SUBJECT: LASALLE COUNTY STATION, UNITS 1 AND 2 - ISSUANCE OF
AMENDMENTS (TAC NOS. MA8403 AND MA8404)

The amendments revise the pressure-temperature (P-T) limits for heatup, cooldown, critical operation and inservice leak and hydrostatic test limitations for the reactor pressure vessel (RPV). The amendments replace the current RPV P-T limit curves with three recalculated curves that are applicable to 32 effective full power years. The staff has approved the revised limits for an interim period not to exceed December 15, 2002.

SAFETY EVALUATION BY THE OFFICE OF NUCLEAR REACTOR REGULATION
RELATED TO AMENDMENT NO. 144 TO FACILITY OPERATING LICENSE NO. NPF-11
AND AMENDMENT NO. 130 TO FACILITY OPERATING LICENSE NO. NPF-18
COMMONWEALTH EDISON COMPANY
LASALLE COUNTY STATION, UNITS 1 AND 2
DOCKET NOS. 50-373 AND 50-374

Figure 3.4.6.1-1

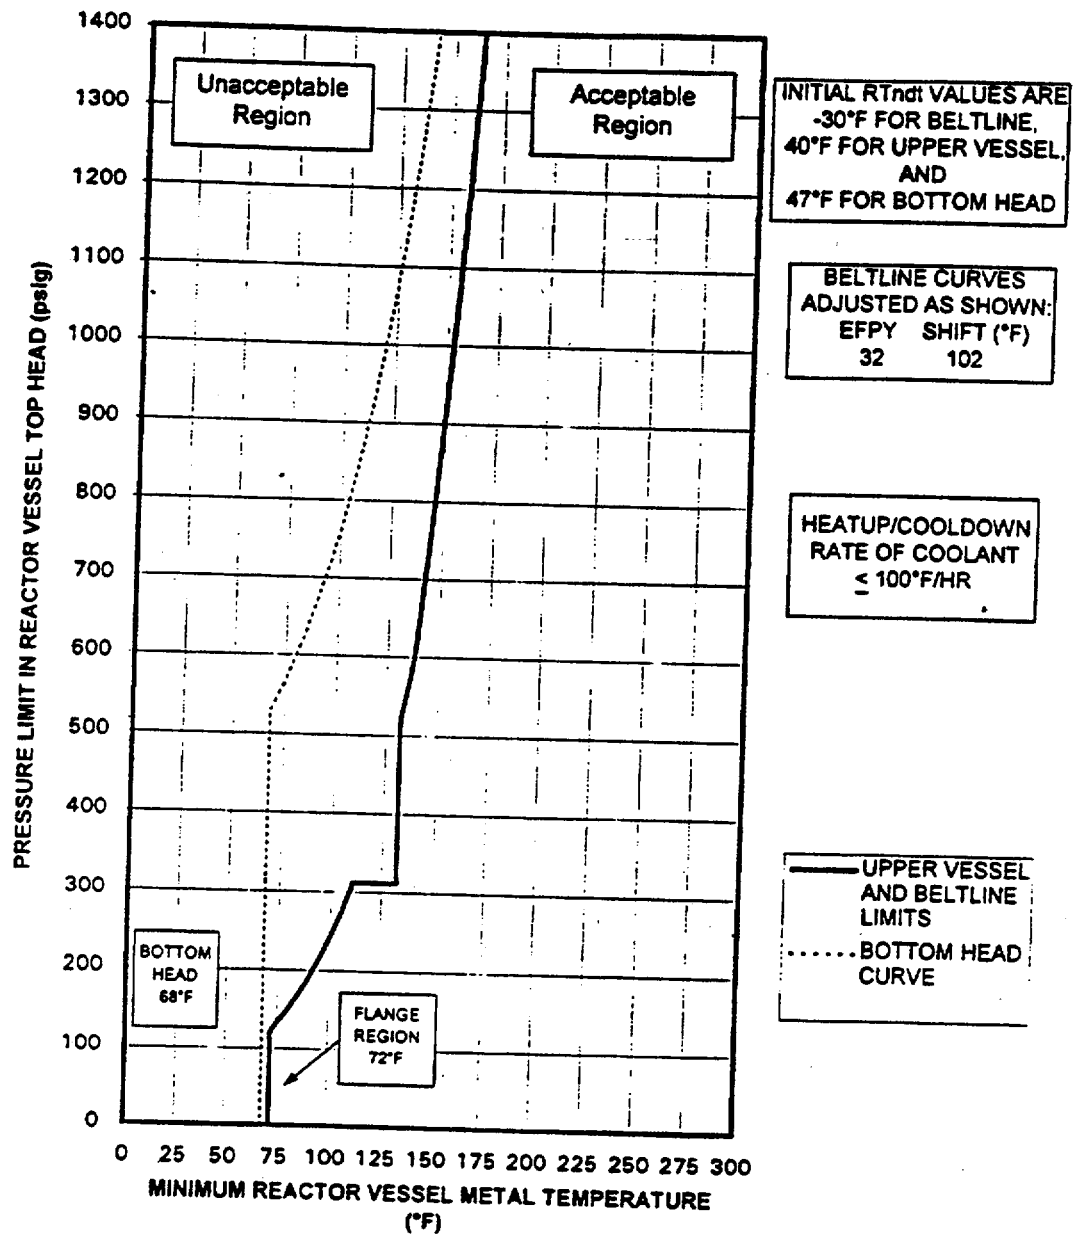
3.4.6.1 The reactor coolant system temperature and pressure shall be limited in accordance with the limit lines shown on Figure 3.4.6.1-1 for hydrostatic or leak testing; Figure 3.4.6.1-1a for heatup by non-nuclear means, cooldown following a nuclear shutdown and low power PHYSICS TESTS; and Figure 3.4.6.1-1b for operations with a critical core other than low power PHYSICS TESTS, with:

4.4.6.1.3 The reactor vessel material specimens shall be removed and examined to determine reactor pressure vessel fluence as a function of time and THERMAL POWER as required by 10 CFR Part 50, Appendix H. The results of these fluence determinations shall be used to update the curves of Figures 3.4.6.1-1, 3.4.6.1-1a, and 3.4.6.1-1b.

Figure 3.4.6.1-1

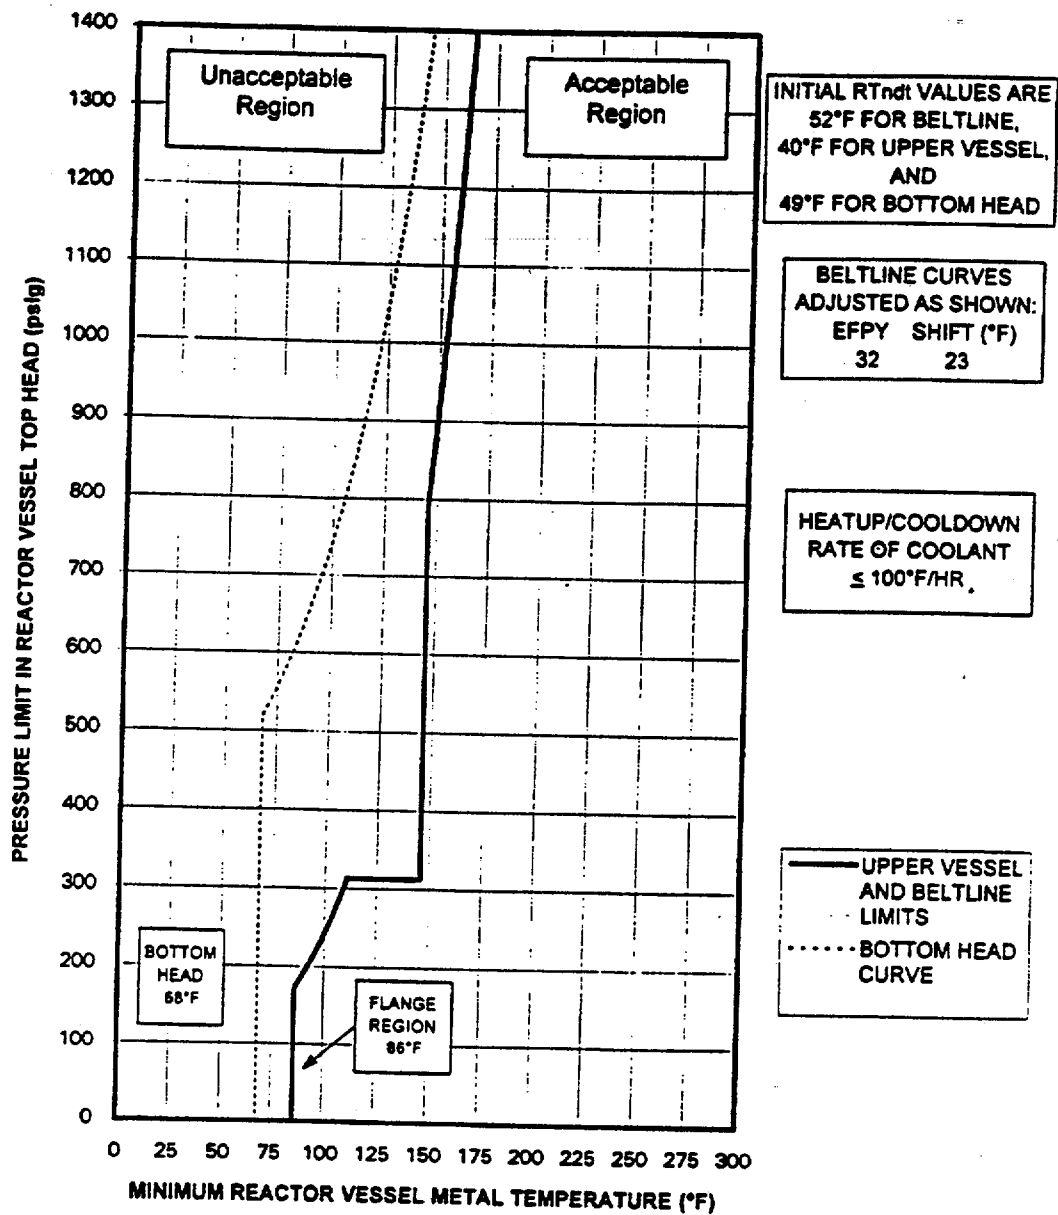
3.4.6.1 The reactor coolant system temperature and pressure shall be limited in accordance with the limit lines shown on Figure 3.4.6.1-1 for hydrostatic or leak testing; Figure 3.4.6.1-1a for heatup by non-nuclear means, cooldown following a nuclear shutdown and low power PHYSICS TESTS; and Figure 3.4.6.1-1b for operations with a critical core other than low power PHYSICS TESTS, with:

4.4.6.1.3 The reactor vessel material specimens shall be removed and examined to determine reactor pressure vessel fluence as a function of time and THERMAL POWER as required by 10 CFR Part 50, Appendix H. The results of these fluence determinations shall be used to update the curves of Figures 3.4.6.1-1, 3.4.6.1-1a, and 3.4.6.1-1b.
